Rezoning Application: PD 22-0866
Zoning Hearing Master Date: January 17, 2023
BOCC Land Use Meeting Date: March 7, 2023

Applicant: Circle K / Schaffer Construction
FLU Category: RP-2 (Residential Planned-2)
Service Area: Rural
Site Acreage: Approximately 3.82 acres
Community Plan Area: Riverview and Southshore Areawide Systems
Overlay: None

APPLICATION NUMBER: PD 22-0866

**RE: *Modified TS-7 Typical Section – Balm Riverview Road
Circle K - Big Bend Road & Balm Riverview Road
PRS 22-0866 and Folio 77690.5320
Design Exception Letter***

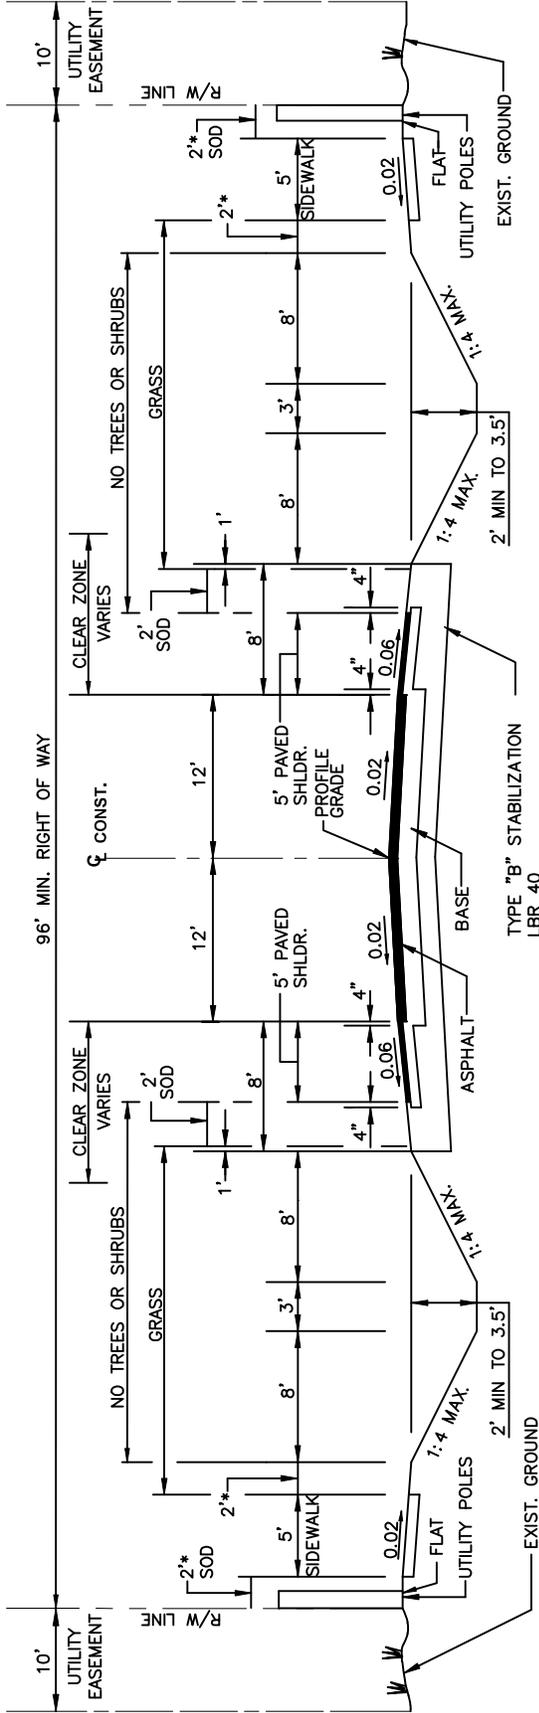
In lieu of reconstructing the roadway to TS-7 standards, the Applicant is proposing to construct their code required 8-foot multi-use path/sidewalk that will run along the western boundary of the site and connect to current terminus of the existing sidewalk located on the property directly south of the project site. To connect with the current terminus of the existing sidewalk, the construction of the multi-use path/sidewalk will span an additional 80 feet into the property located directly south of the project site. The site plan, included in **Appendix A**, identifies the proposed limits of the multi-use path/sidewalk.

The project is proposed to have one (1) right-in/right-out only (RIRO) connection along Balm Riverview Road. Typical site design for a RIRO driveway does not include the construction of a raised median. However, based upon discussions with Hillsborough County, a 2-foot raised median is proposed for construction along Balm Riverview Road between the northbound left-turn lane and the southbound travel lane at the proposed RIRO driveway to prohibit left-turns in/out of the site. The proposed 2-foot median is illustrated in the site plan in **Appendix A**.

To fully address the substandard typical section for Balm Riverview Road, the roadway will need to be widened to include a 5-foot bike lane along the east side of the roadway. The subsequent cost of this improvement would not be cost feasible for the proposed development and, thus, provide an unreasonable burden for the Applicant. Additional benefits and justifications for this Design Exception are discussed in further sections of this letter.

**RE: *Modified TS-7 Typical Section – Big Bend Road
Circle K - Big Bend Road & Balm Riverview Road
PRS 22-0866 and Folio 77690.5320
Design Exception Letter***

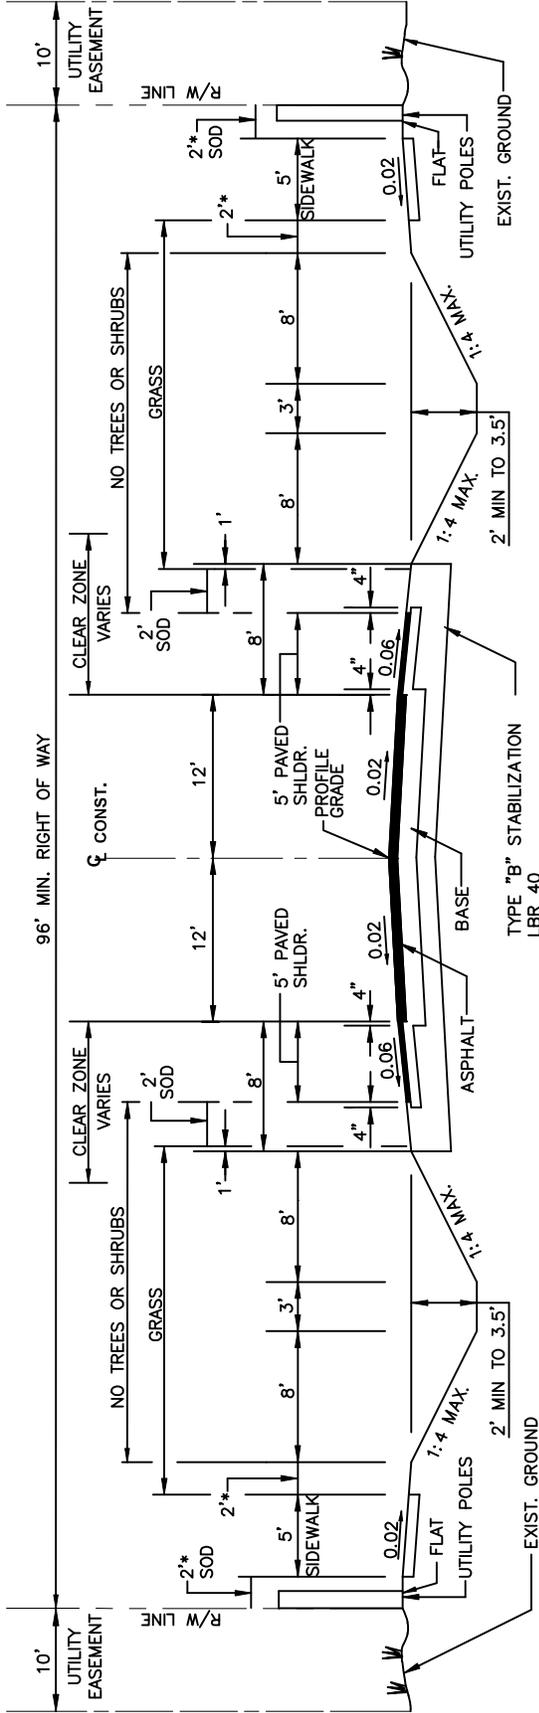
At an unsignalized intersection, the length of a right-turn lane is the sum of the deceleration and taper length. According to the 2022 FDM Exhibit 212-1, the total deceleration and taper distance for a roadway with a posted speed limit of 35 miles per hour (mph) is 145 feet. As indicated in the site plan (**Appendix A**), the Applicant is proposing to construct an eastbound right-turn lane of 195 feet. The proposed eastbound right-turn lane provides an additional 50 feet of deceleration distance.

For the proposed eastbound right-turn lane, the Applicant is proposing to construct a turn lane that exceeds the required turn lane length. As discussed later in this letter, this positive deviation from Hillsborough County’s standards is intended to provide additional safety and operational benefits at the project’s proposed access point along Big Bend Road.

these improvements would not be cost feasible for the proposed development and, thus, provide an unreasonable burden for the Applicant. Additionally, any potential widening adjacent to the site would affect the recently constructed improvements to the intersection of Big Bend Road & Balm Riverview Road. Additional benefits and justifications for this Design Exception are discussed in further sections of this letter.
